April 18, 2018

RE: Heritage Trails Subdivision
Drainage Report Stamp Date: 3/15/18
Drainage Report Supplement Stamp Date: 4/13/18
Grading Plan Stamp Date: 4/13/18
Hydrology File: N08D006F

Based on the information provided on 4/13/18 and previous submittals, the Drainage Report, Drainage Report Supplement, and Grading Plan are approved for Preliminary Plat and Grading Permit.

Based on the information provided in your submittal received on 3/30/18, the Drainage Report and Grading Plan cannot be approved for Preliminary Plat or Grading Permit until the following are corrected and a revised Drainage Report and Grading Plan are submitted.

SECTION F - POND DETAIL

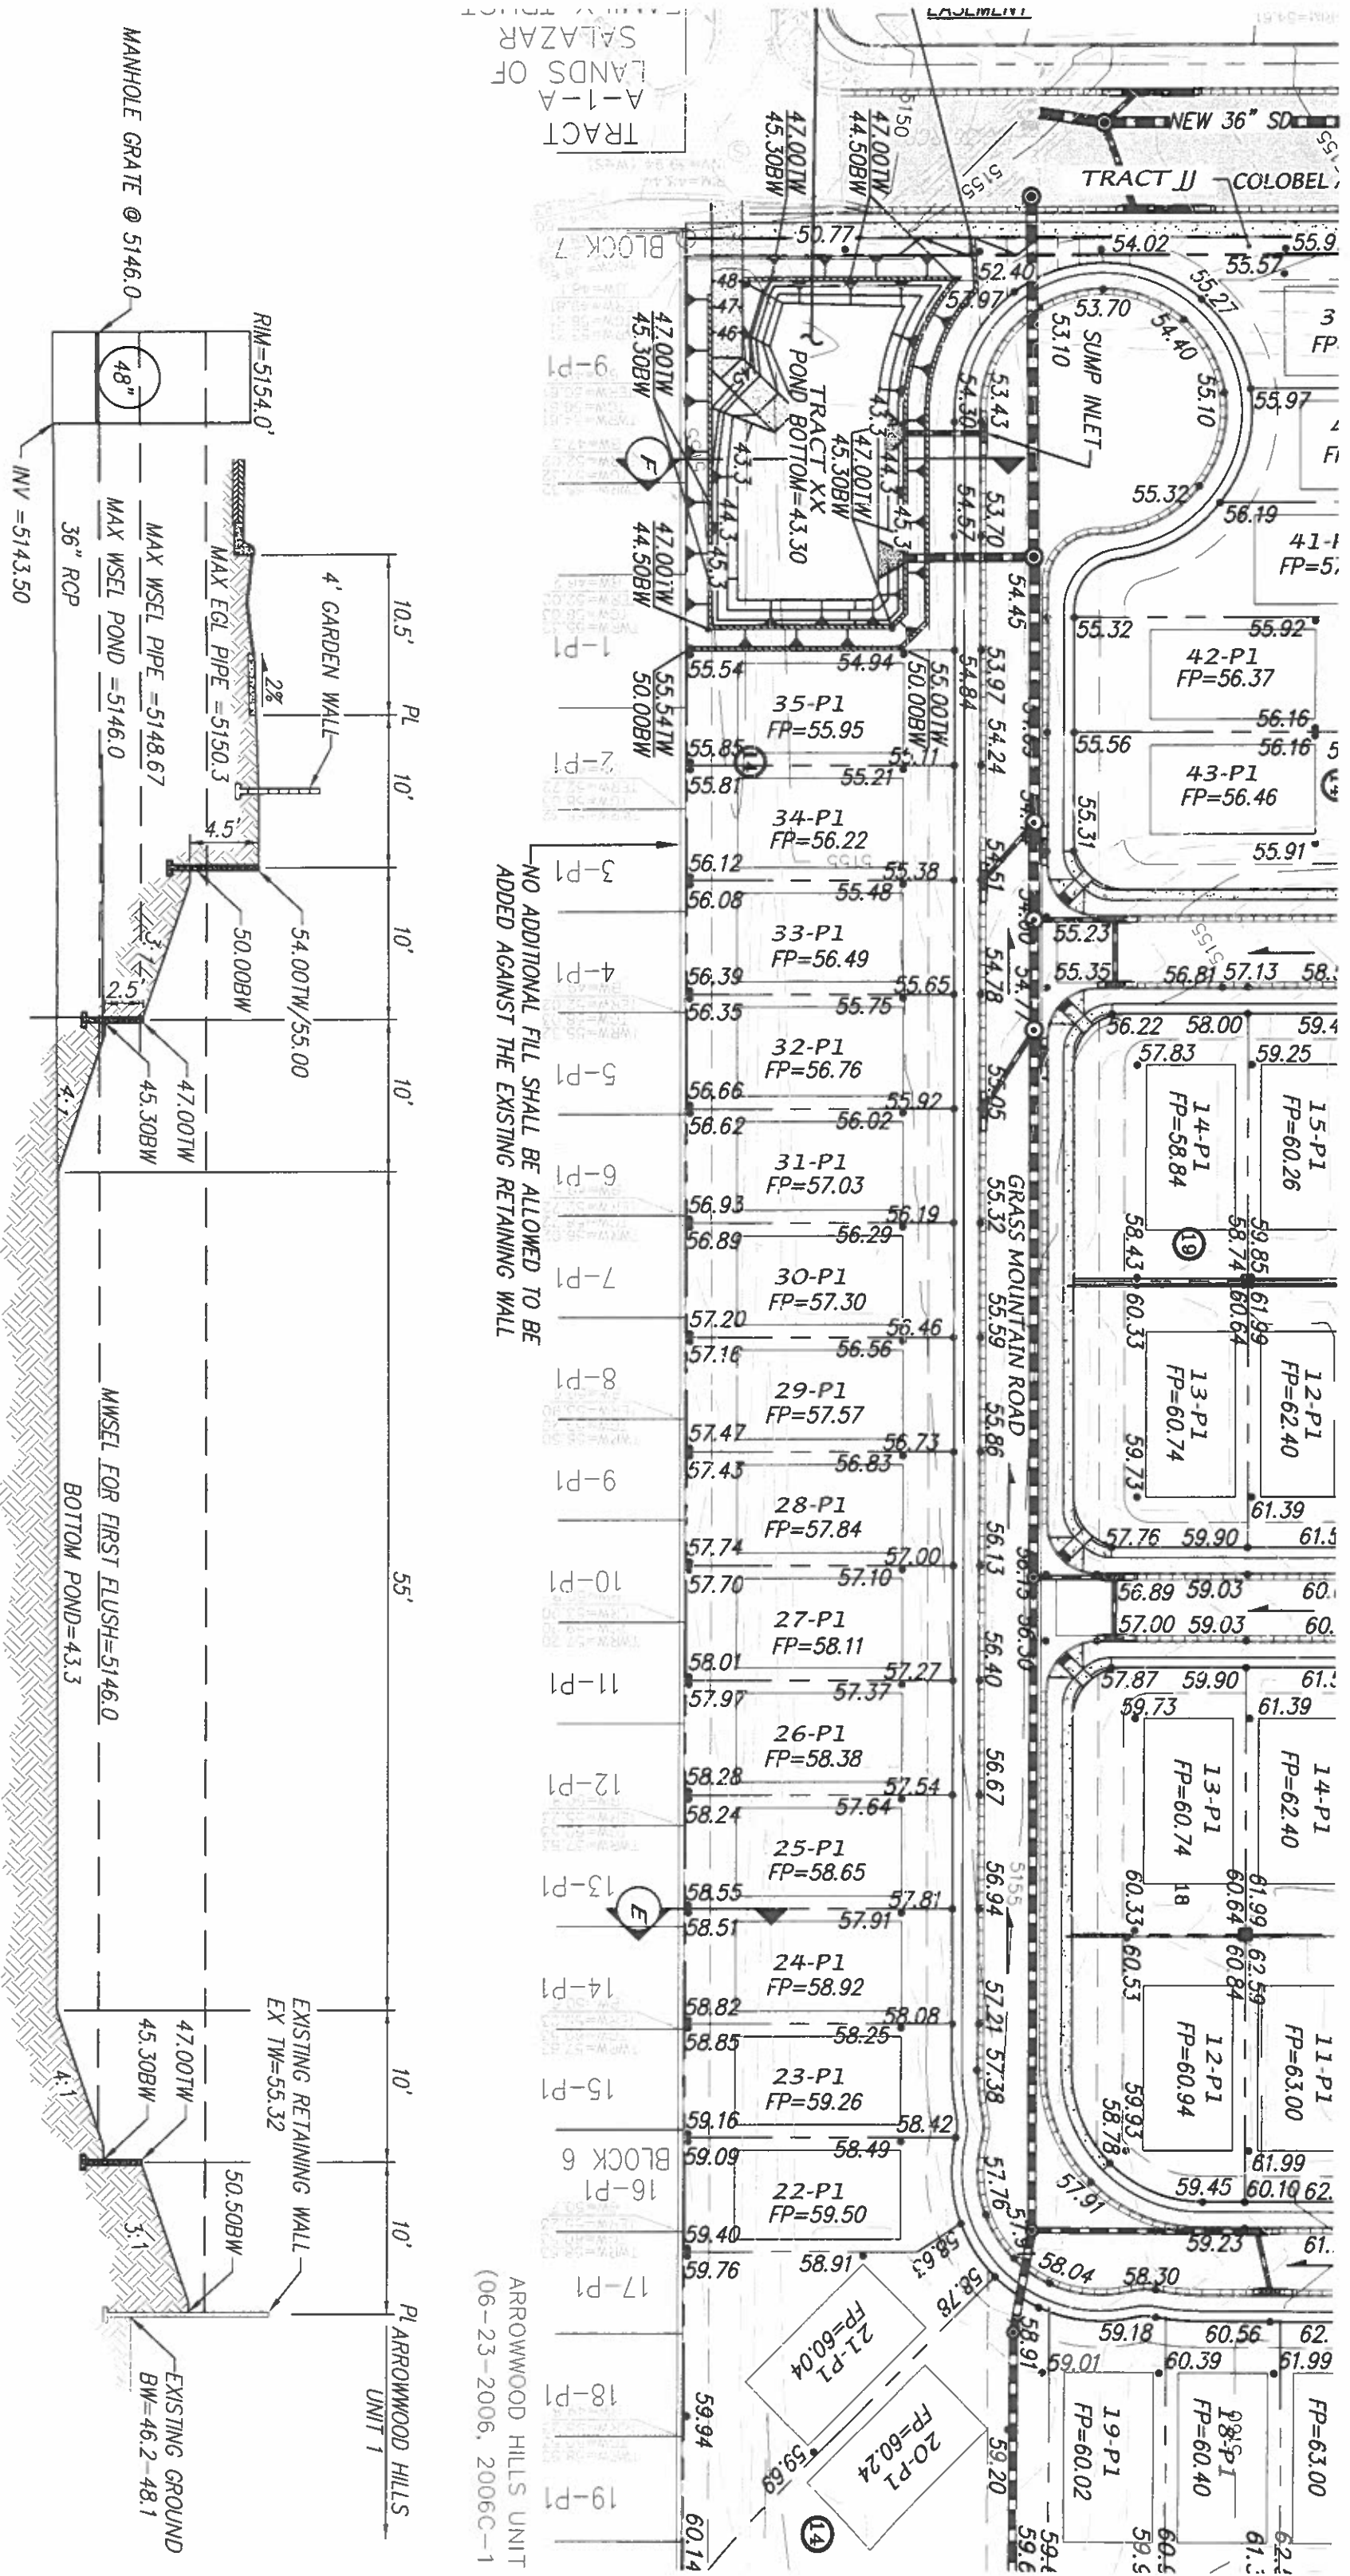
3. The estimated maximum water surface elevation of 5145.4' in the unit 1 first flush pond is significantly less than the HGL elevation of 5150.5' or the EGL of 5151.7' provided in the WSPGW model. It appears the MWSE in the pond will be governed by the EGL, leading to water ponding against the existing garden wall bordering Arrowwood subdivision. Provide a solution to prevent ponding and saturated conditions against the existing wall and update the grading plan and Section F accordingly.

PROJECT Heritage Trails
SUBJECT Lot 9, Block 13, Unit 1
BY _____ DATE _____
CHECKED _____ DATE 4-10-18
SHEET _____ OF _____

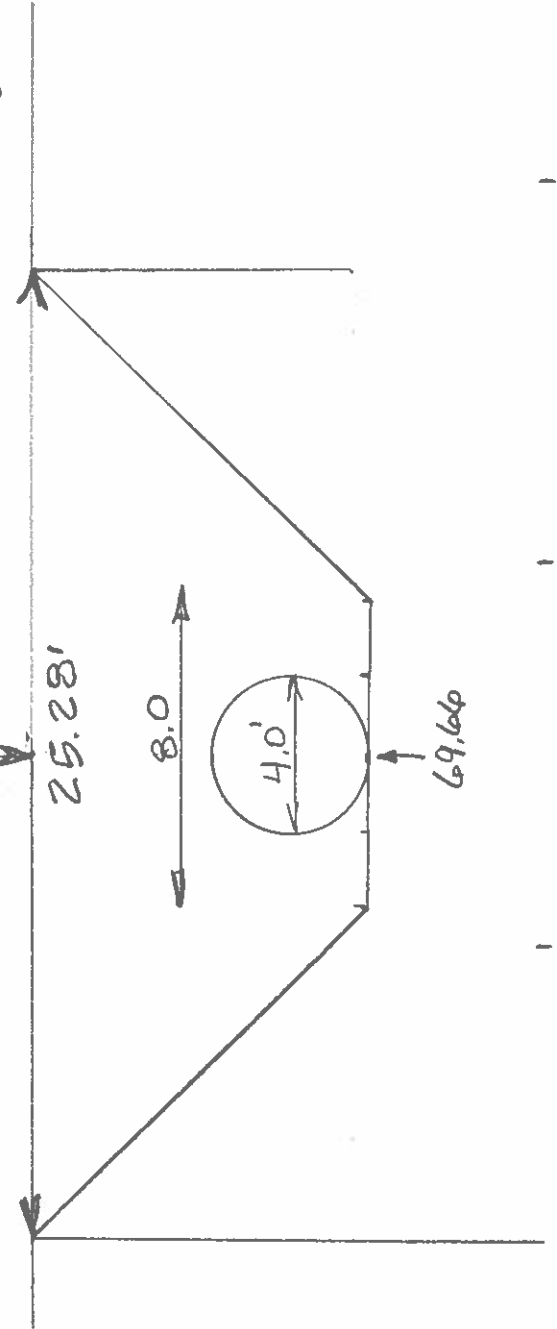
- a. Inlets B6.
 - b. Inlet B11.
2. Reconfirm the trenching prism across Unit 1, Block 13, Lot 9. Provide the new pipe size, invert, finished grade elevation, and calculations used to justify the 24' easement.

1. Per your design revision request, additional manholes and straight lateral connections have been made at B6 and B11.
2. The required drainage easement across Lot 9, Block 13, Unit 1 was calculated to be 25.28'. The easement has been revised to be 26 feet. A trench prism details has been added to the drainage report supplemental information.
3. The outfall from Unit 1 pond was design to allow discharge out of the pond with 1' of head. I understand your concern about the EGL being at 5150.0. I have redesigned the Unit 1 first flush pond to eliminate the backwater effect at the outfall. I have raised the ground elevation along the east property boundary to 5150.5 which should be now at the maximum EGL elevation. The grading plan has been revised to reflect the design change.
4. First Flush ponds have a label now "to be constructed by work order" on the grading plan.
